ORE DRESSING AND METALLURGICAL LABORATORIES.

Investigation No. 2170.

Investigation of the Premature Failure
of an SAE 4340 Fan Shaft.

Figure 2.

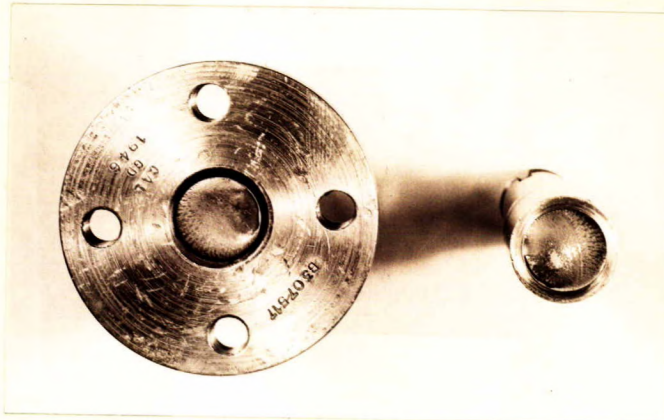
In the visual examination, it was noticed that the broken shaft had a conchoidal, or "oyster-shell", type of fracture (see Figure 2). This type of fracture is typical of a fatigue failure where the rate of propagation of a crack preceding the final break is not constant. Consideration of the fan assembly and shaft design (see Figures 3 and 4) reveals the following significant facts. The finished shaft has an integral collar with sharp, 90° faces. High stress concentrations may therefore be expected at either end of the collar. A press fit is used to secure the hub to the shaft and a sharp right angle exists between the hub face and the shaft. Hence at the shaft collar, a definitely critical area, there will be a further increase in stress concentration due to the "notch" effect of such design features. It will be noted that failure occurred at this point.

5. The fracture of the fan shaft is attributed to fatigue failure arising from the "notch" effect of the design features and the presence of a soft surface deposit at a critical area.

1. It is recommended that changes be made in the design, to incorporate fillets at areas of high stress concentration. A solid hub and shaft component, with a generous fillet at the junction of the hub face and shaft, should eliminate many of the stress-raising features of the present design.

FAN DRIVE ARRANGEMENT.

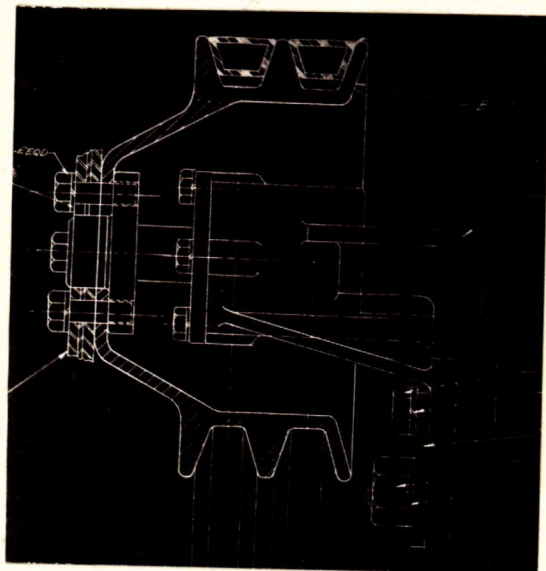
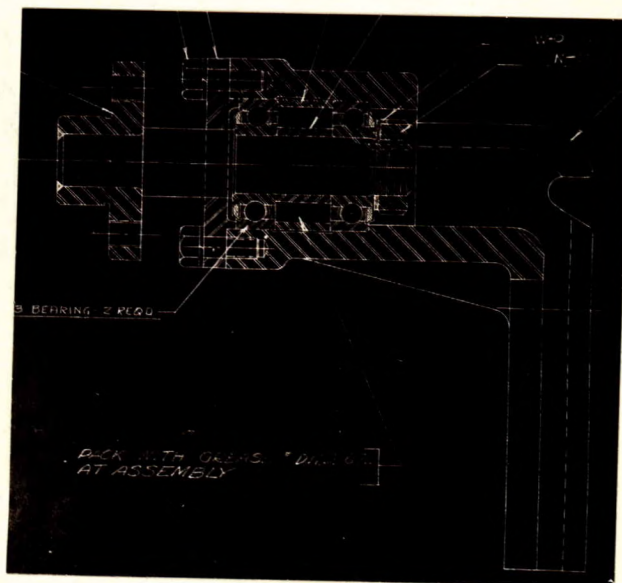
4. Several features in the design were noticed which would have a stress-raising effect in localized areas. These features, consisting chiefly of a press fit and sharp 90° angles at critical areas, are outlined in the discussion.

Figure 5.

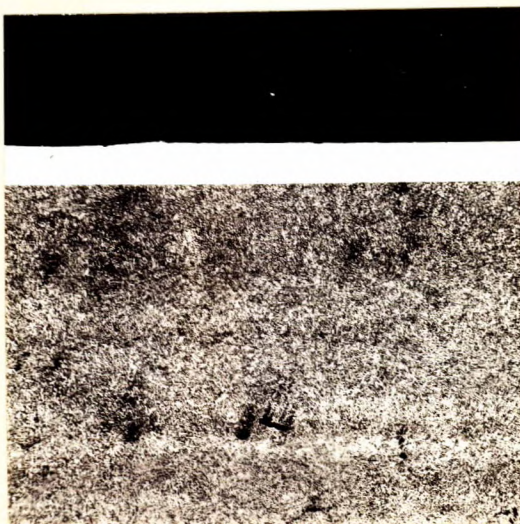
Metallographic examination revealed the presence of a surface deposit, 0.002 inch thick, on a specimen representing that part of the shaft which fitted into the hub. The hardness of this deposit, which was identified as nickel, was Rockwell "C" 12 (converted from a Knoop number 217 taken

The presence of the nickel layer at such a critical area undoubtedly had an adverse effect on the endurance limit of the part. Since the maximum stress developed is at the surface of the fan shaft, the presence of a soft weak skin would favour the initiation of a fatigue crack. On continued service, such a crack would propagate into the harder core. The fatigue failure is attributed to the stress-raising "notch" effect of the design in conjunction with this soft surface deposit.

2. In this assembly the use of nickel plating to rebuild a misfitting fan shaft should be discontinued. Any shafts thus plated should be removed from service.

Figure 6.

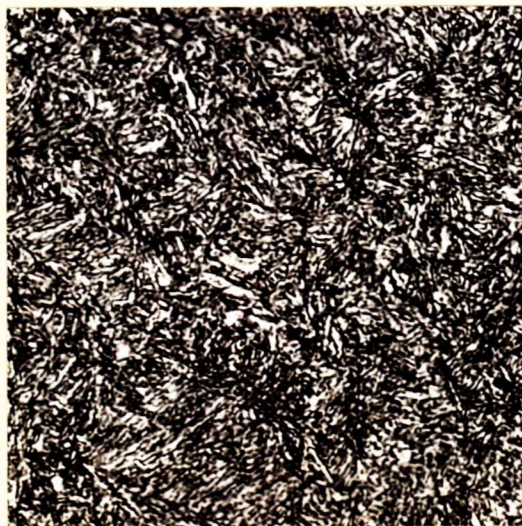
Hardness values of Rockwell "C" 38 to 41 were obtained across the diameter of the unplated shaft. These values were above the maximum of the reported specified limits of Rockwell "C" 35 ± 3. The hardness values obtained are not considered to be a contributing factor towards failure in this instance.

While increasing the hardness (tensile strength and hence endurance limit) through cold working or heat treatment, is sometimes used to improve the fatigue limit of a steel, it should be borne in mind that this effect holds true only in the absence of "notch" effects. Since the notch sensitivity of a steel also increases with hardness, there will be a resultant decrease in the endurance limit of a component subject to the "notch" effect.
